# Conceptual Review Agenda

Schedule for 11/30/15 to 11/30/15

# 4450 Denrose Ct Vehicle Major Repair

**Description of project:** This is a request to locate a vehicle major repair shop at 4450 Denrose Ct. (parcel #8715216001). This will be a change of use to vehicle major repair from unlimited indoor recreation with no alterations to the existing building. The site is served by 82 parking spaces. The parcel is located in the General Commercial (CG) zone district. This proposal will be subject to a Minor Amendment.

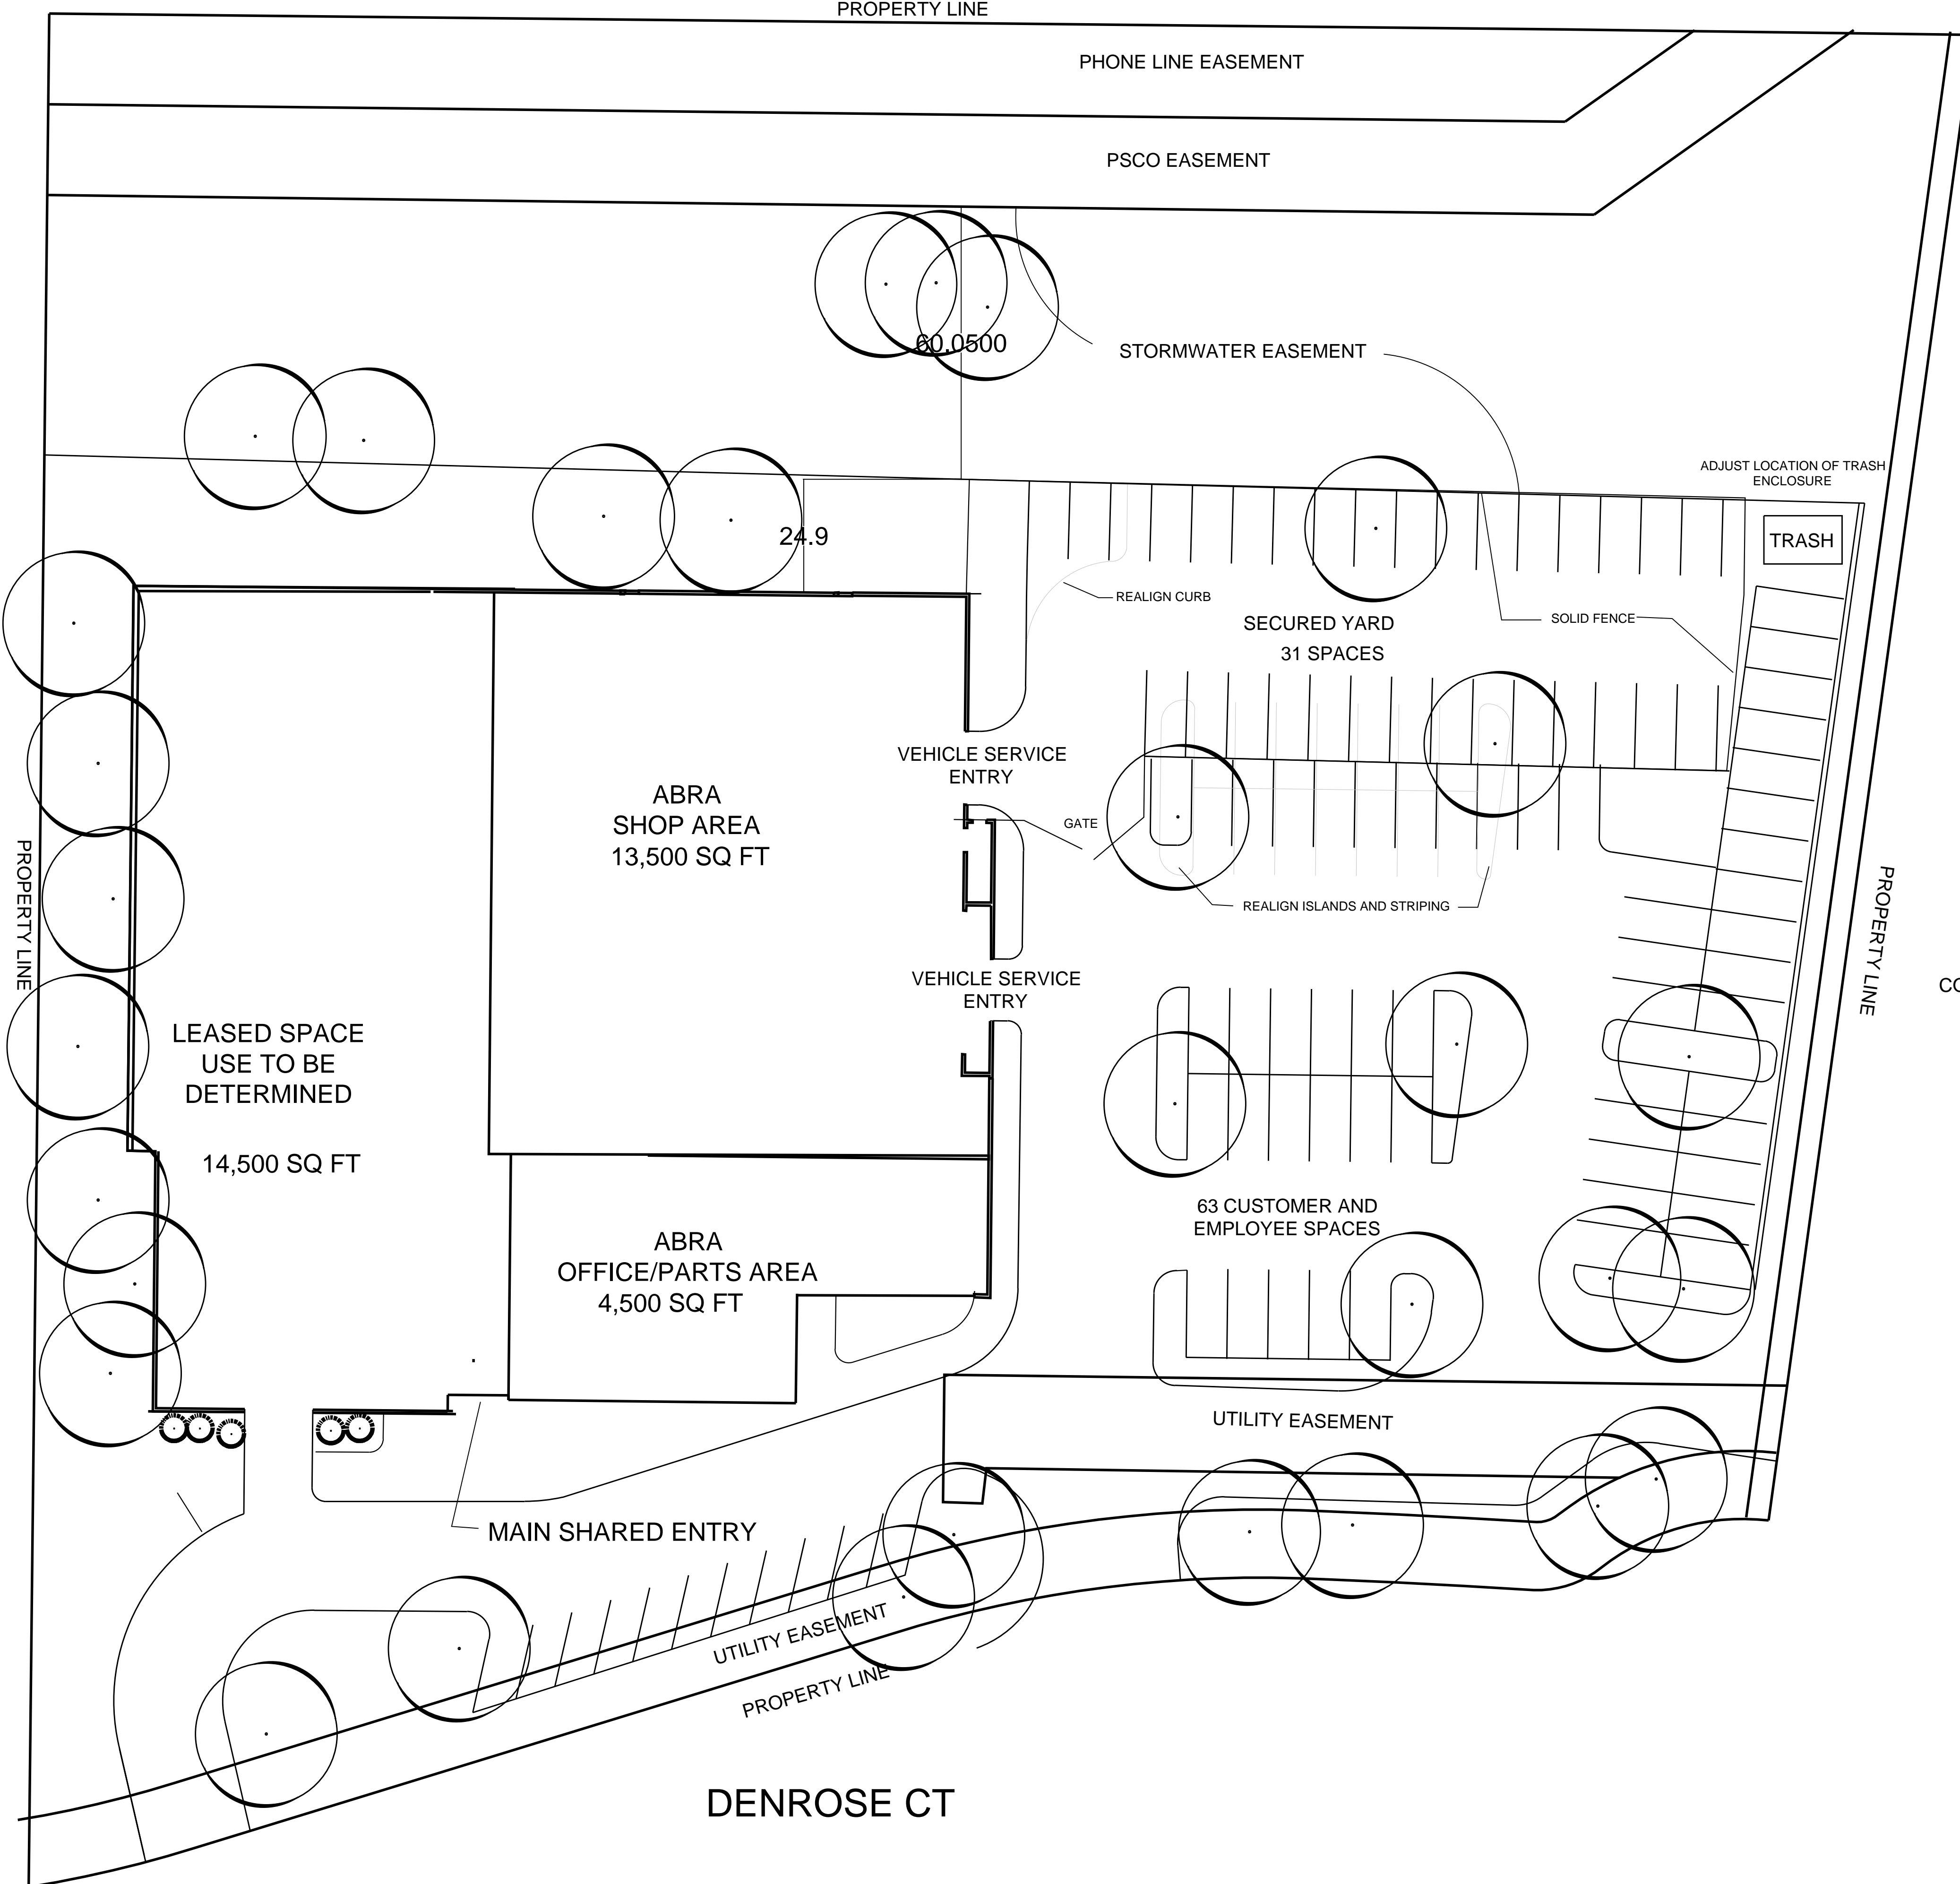
2. LUC 3.2.2(C)(4)(b) You have a minimum bicycle parking requirement of 4 spaces, all of these spaces could be fixed bicycle racks.
3. LUC 3.2.1 A landscape plan is required.

4. LUC 3.2.5 All development shall provide adequately sized conveniently located, accessible trash and recycling enclosures. Please provide plan and elevation drawings of the enclosure.

1. All proposed fencing will have to meet the standards outlined in section 3.8.11 of the Land Use Code. The fencing must also meet the code standards of section 3.9.8. Chain link fences are prohibited for screening. Fencing must consist of high quality materials such as wood, stone, masonry, or ornamental metal. Fences and walls shall be set back at least six (6) feet from the back edge of an adjoining public sidewalk, and such setback area shall be landscaped with turf, shrubs and/or trees, using a variety of species to provide seasonal color and plant variety. The maximum length of fence without a change in plane or materials shall be 40 feet.

3. 6% of the interior of the parking lot will need to be landscaped per Land Use Code section 3.2.1(E)(5).
4. All vehicle use areas will need to be screened from abutting uses and the street per Land Use Code section 3.2.1(E)(4). You will be able to achieve this code standard partly with the fence along Mulberry. Additionally, the screening must meet the standards outlined in 3.9.4 since the site is within the I-25 Subarea Plan boundaries. For the other sides of the parking lot, please provide either landscaping, fencing, or a low wall along 75% of the perimeter that mitigates the impact of shining headlights.
